Report on Review of Bay Delta Conservation Program Modeling

Since December 2012, MBK Engineers and Dan Steiner (collectively “Reviewers”) have assisted various parties in evaluating the operations modeling that was performed for the Bay Delta Conservation Plan (BDCP). To assist in understanding BDCP and the potential implications, stakeholders¹ requested that the Reviewers review the CalSim II modeling studies performed as part of the BDCP (hereafter “BDCP Studies” or “BDCP Model”).

Figure 24. Delta Outflow Change (Alt 4-ELT minus NAA-ELT)

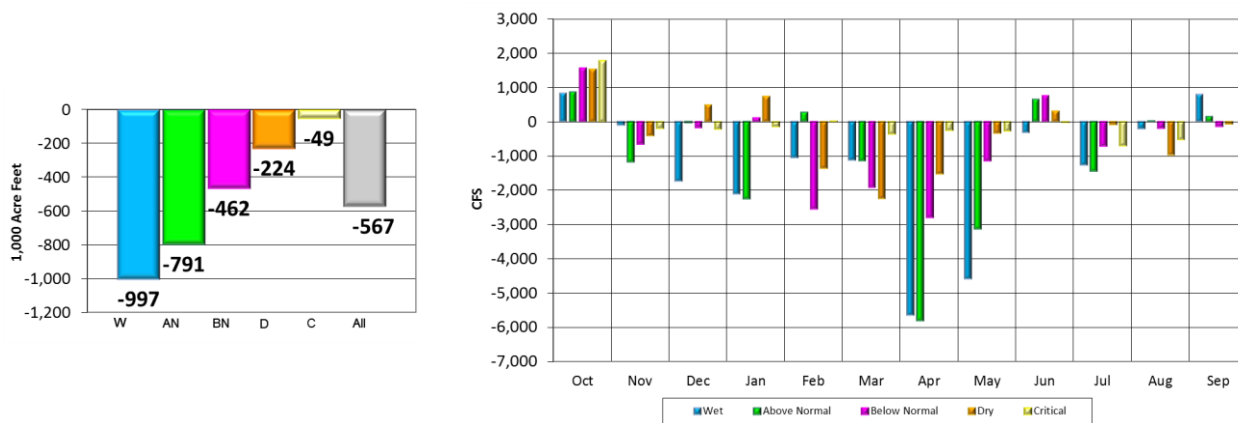
Figure 24 illustrates a comparison of Delta outflow between the NAA-ELT and Alt 4-ELT. Decreases in Delta outflow are the result of the CVP and SWP ability to increase Delta exports in Alt 4-ELT. The apparent increase in Delta outflow in October is partially due to additional export restrictions though Old and Middle River flow requirements. However, the increase in October Delta outflow is also due to an unrealistic operation of the Delta Cross Channel. The additional export restrictions cause the flow standards imposed at Rio Vista to be the controlling point in CVP and SWP operations; the water quality standards are all being met and do not require

flows above the amount needed to satisfy the Rio Vista standard. Meeting the Rio Vista flow standards without closing the Delta Cross Channel gate results in releasing more water from upstream reservoirs than would otherwise be necessary. This occurs because a certain amount of the water released to meet the Rio Vista flow standards would flow into the Central Delta at location of the Delta Cross Channel gate. This water would not make it to Rio Vista and therefore would not be counted towards meeting the Rio Vista flow standards. However, due to the BDCP model's assumed restrictions on exports at this time, this water could not be pumped from the South Delta facilities and thus ends up as "extra" Delta outflow. By closing the Delta Cross Channel gate, the operators would assure that all of the water released to meet the Rio Vista flow standards would be counted towards those standards. The BDCP model's assumptions that the Delta Cross Channel gate would not be closed are not practical or a sensible operation as the operators confirmed they would close the gate during these conditions to avoid the unnecessary loss of water supplies (as was done in October and November 2013). The assumption in the BDCP model to maintain the gate in the open position causes it to overstate the amount of Delta outflow.

Figure 44. Alt 4 North Delta Diversion Versus South Delta Diversion for July, August, and September

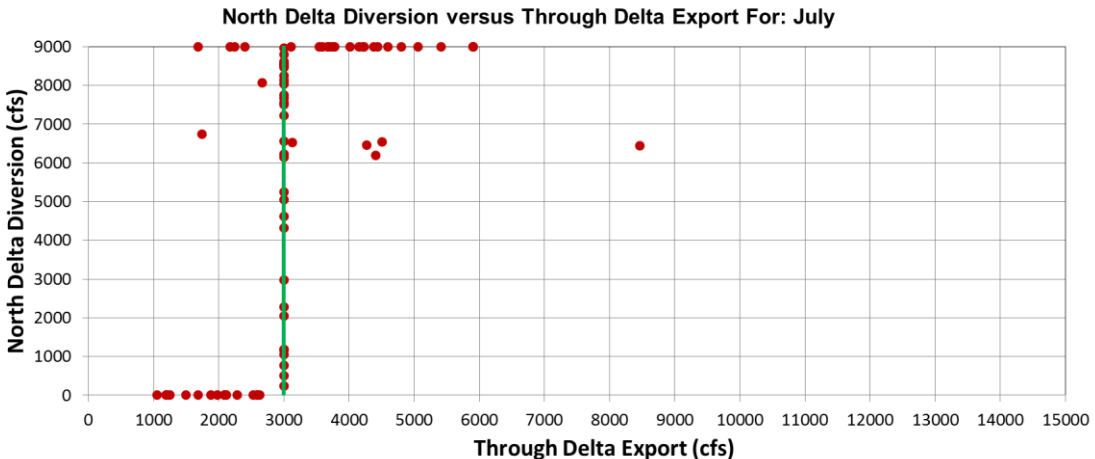
Figure 44 contains modeling results from Alt 4 for July, August, and September that plot NDD against SDD (Through Delta Export). There are many occasions when SDD are 3,000 cfs, which is due to criteria specifying that SDD during this time period need to be at least 3,000 cfs prior to diverting at the NDD facility. Although there are about six occurrences in July and three in August where the model did not satisfy this criterion, this issue has not yet been addressed for this modeling effort.

Figure 60. NDD, and Sacramento River Flow

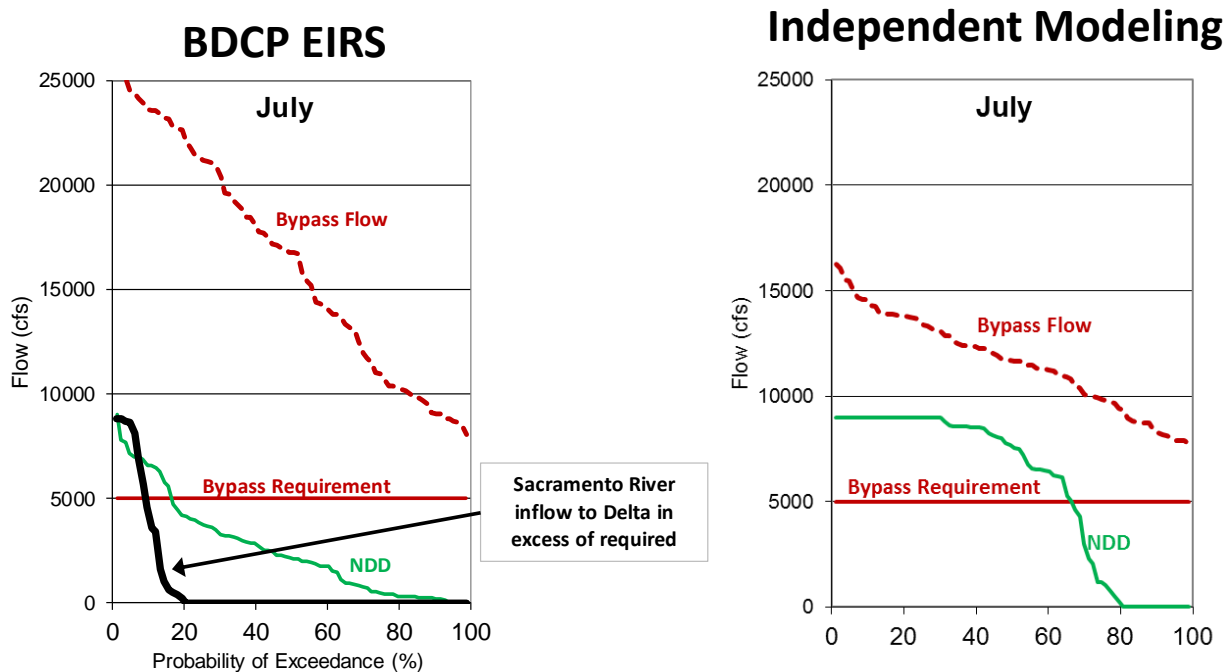
Independent modeling shows greater NDD during July and other months because the BDCP EIRS modeling includes artificially high Sacramento River bypass flow requirements. Figure 60 contains exceedance probability plots of Sacramento River required bypass, Sacramento River bypass flow, NDD, and excess Sacramento River flow to the Delta. As can be seen in Figure 60, bypass flow is always above the bypass requirement. The BDCP version of CalSim sets a requirement for Sacramento River inflow to the Delta that the independent modeling does not need in order to satisfy Delta requirements, therefore the NDD is higher in the independent modeling.
